STAFF RECOMMENDATION

307 South 10th Street

February 20, 2019

Description of Project: Application is to construct duplex infill and two outbuildings.

Figure 5: Left side elevation

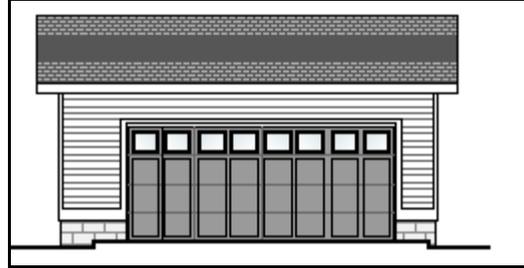
Proportion and Rhythm of Openings: The windows are all generally twice as tall as they are wide, thereby meeting the historic proportions of openings. There are no large expanses of wall space without a window or door opening. Staff finds the project's proportion and rhythm of openings to meet Section II.B.7.

307 S 10TH AVENUE
 EDGEFIELD HISTORIC PRESERVATION OVERLAY
 SITE PLAN • SCALE: 1"=20'

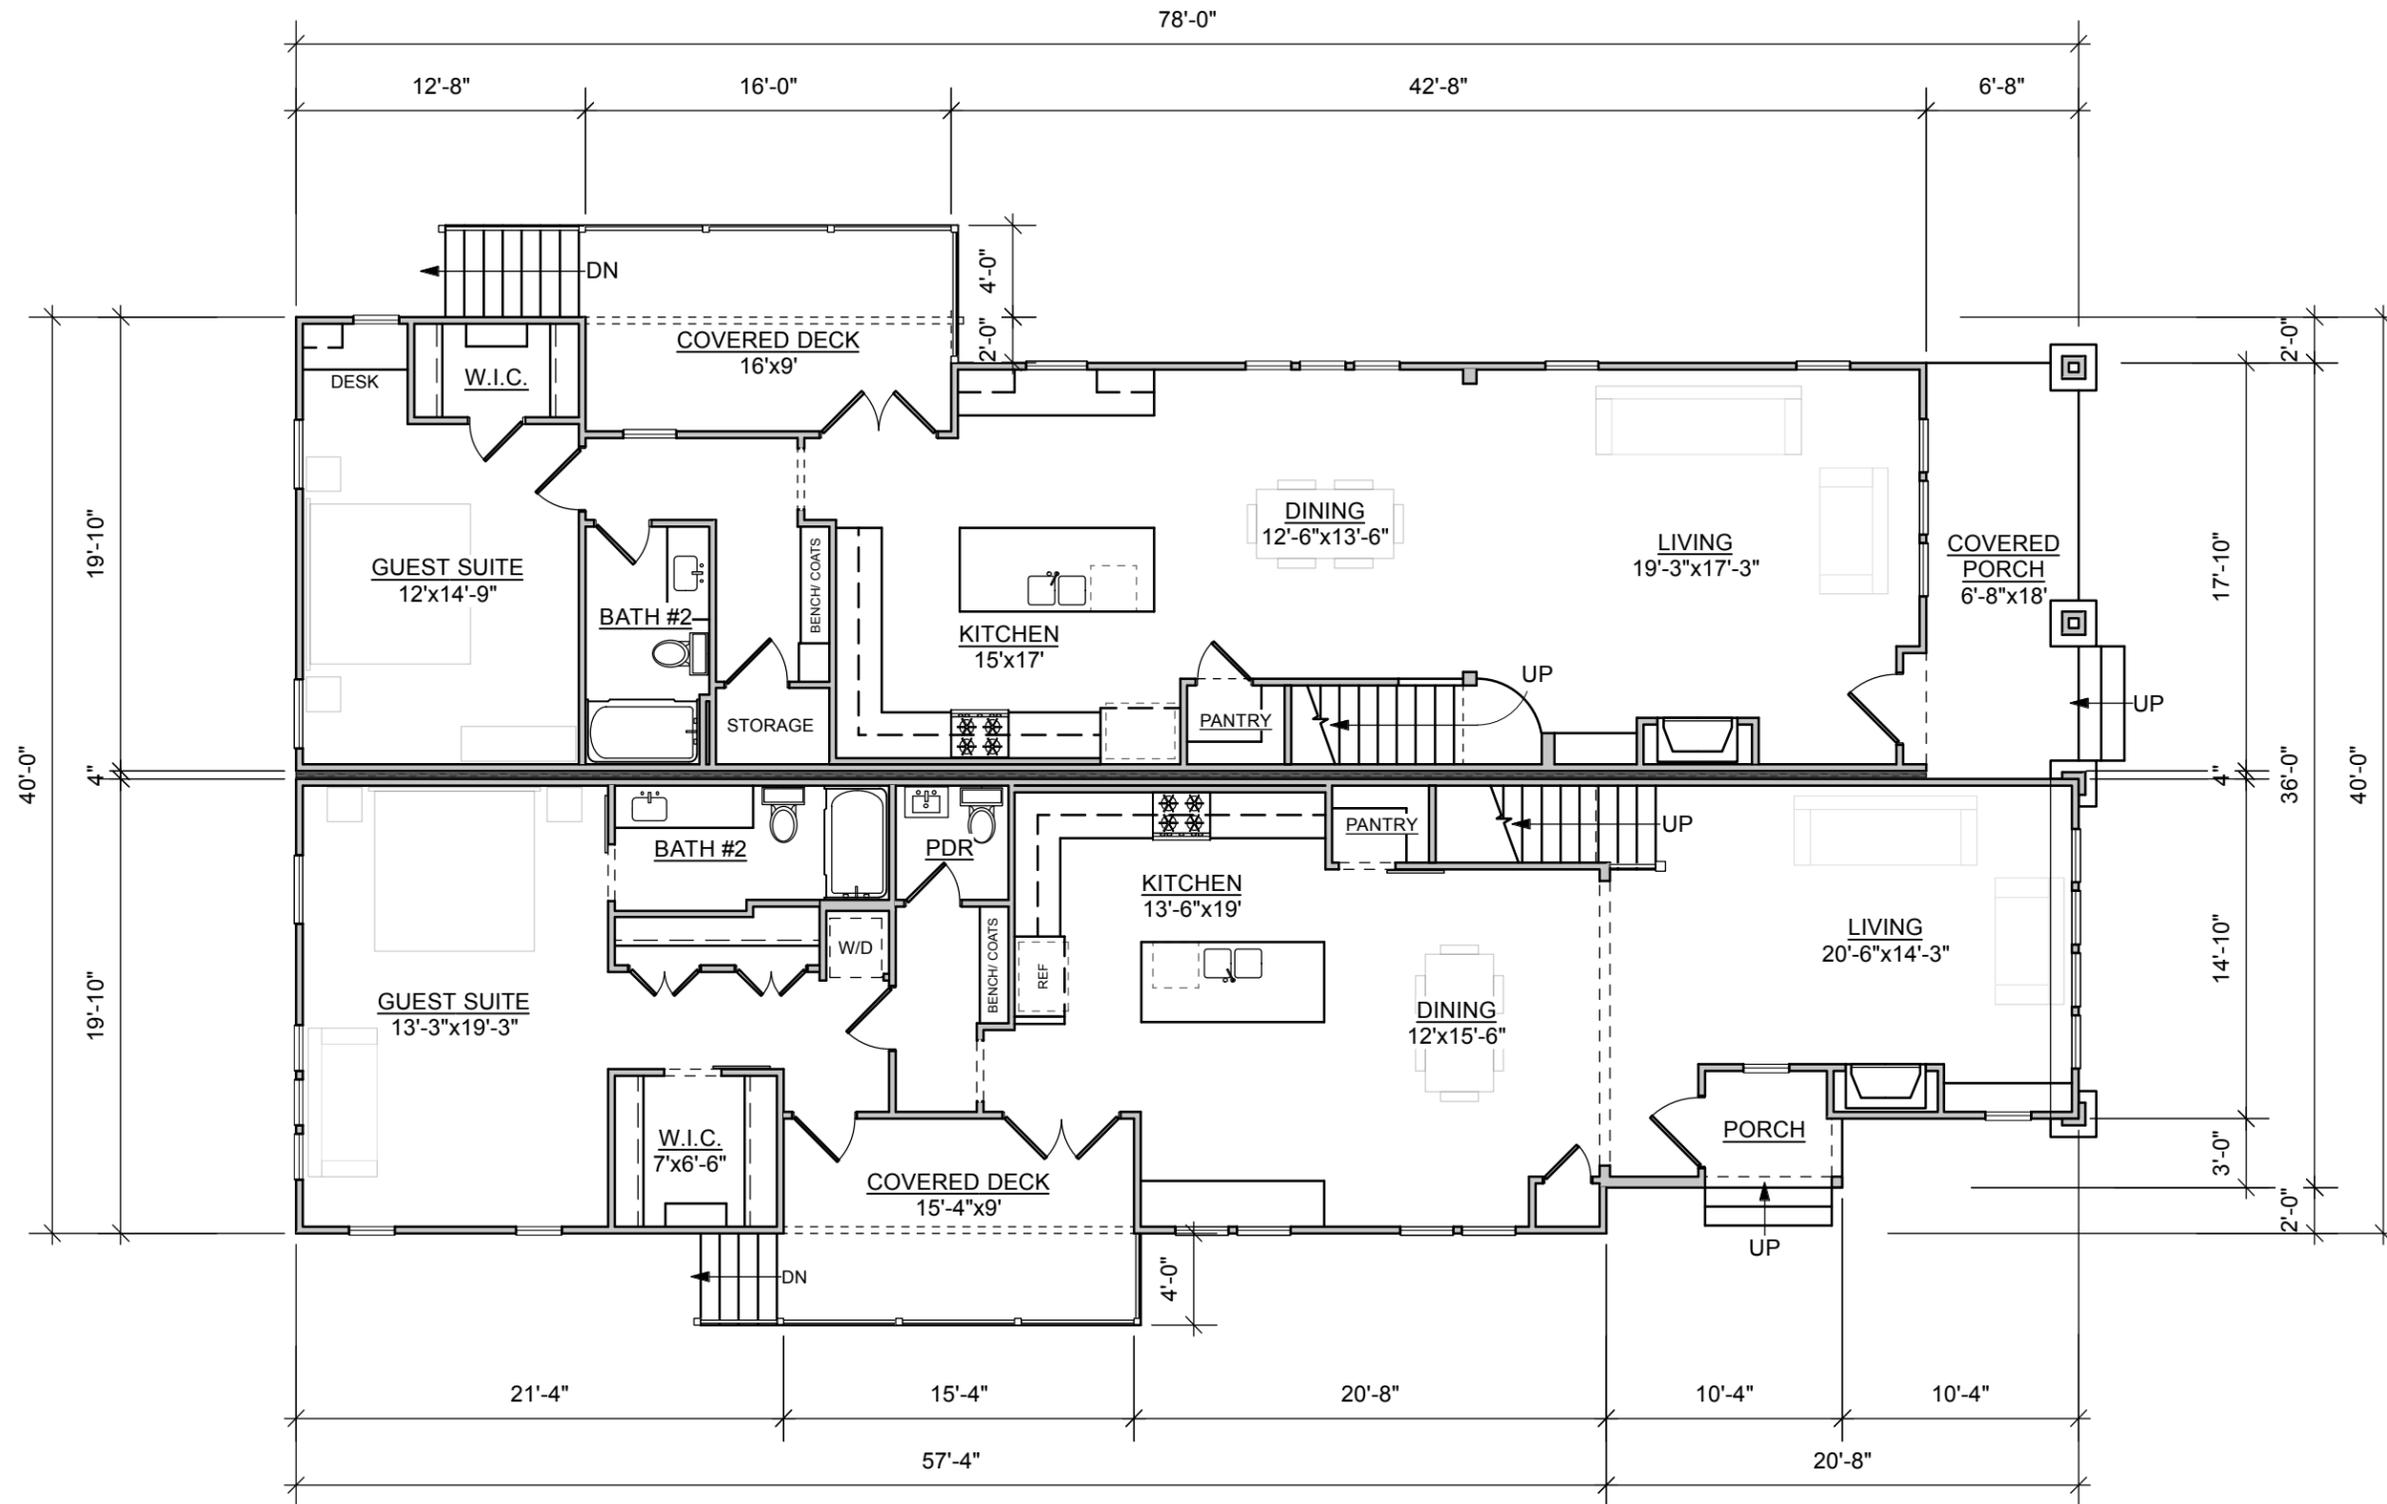
Setback & Rhythm of Spacing: The front setback is proposed to be about forty-one feet (41') from the front property line (about thirty-seven feet (37') from the edge of the

sidewalk). The house to the right is about forty-eight feet, six inches (48'6") from the property line and the house to the left is about thirty-eight feet, six inches (38'6") from the property line. Setting the new house back between the setbacks of the existing houses is appropriate.

At its widest point, the house will be setback nine feet, five and a half inches (9'5 1/2") on both sides. Uncovered decks will extend further on both sides, but will not encroach into the required five foot (5') setback on either side.

The rear of the duplex will be about eighty-six feet (86') from the rear property line.

As there is no historic context, there is no rhythm of spacing to preserve. The house sets back a reasonable distance from the street and its street-front width does not max out the buildable area, at thirty-three feet (33') wide, stepping back to a maximum of forty feet (40') further back on the lot. Staff finds that the project meets section II.B.3.
